SUNDRY NOTICES AND REPORTS ON WELLS

MARRON 23 #3

NAME CHANGE to APD

Revised Drilling Program
2/2/04

WELL LOCATION AND ACREAGE DEDICATION PLAT

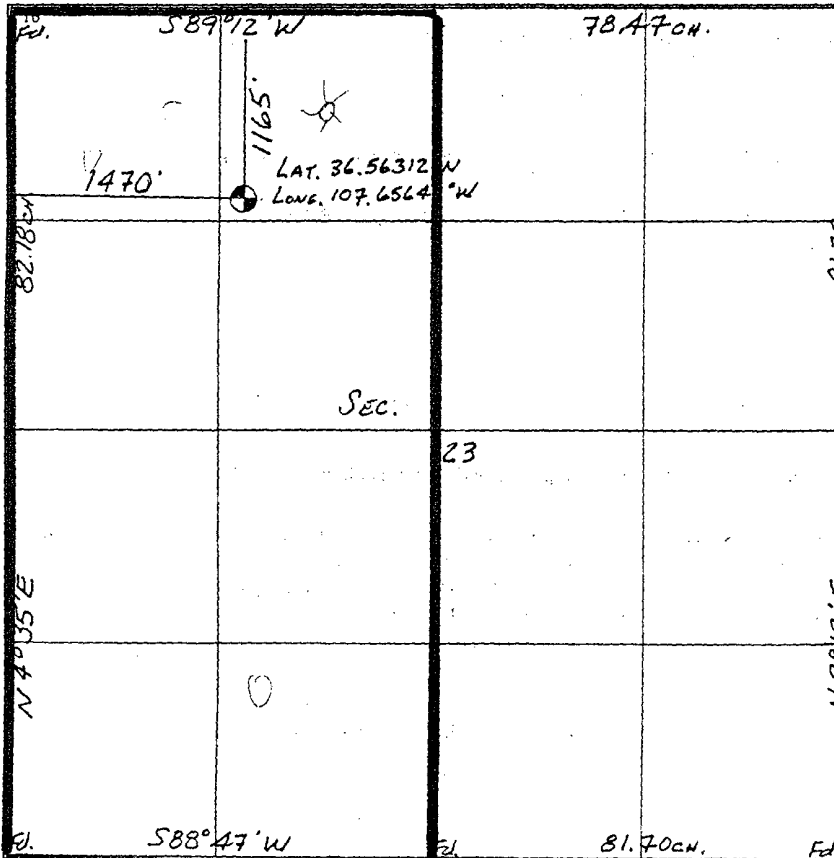
M & G Drilling Company Inc. has decided to change plans and mud drill a single Blanco Mesaverde well with 8-5-8" surface casing set at about 280' and 4-1/2" production casing set at about 4790'. Attached is the new 8 point drilling plan and a new C-102. This well was formerly to be a deviated Mesaverde/Dakota commingled well with an APD that was approved on 12/30/03.
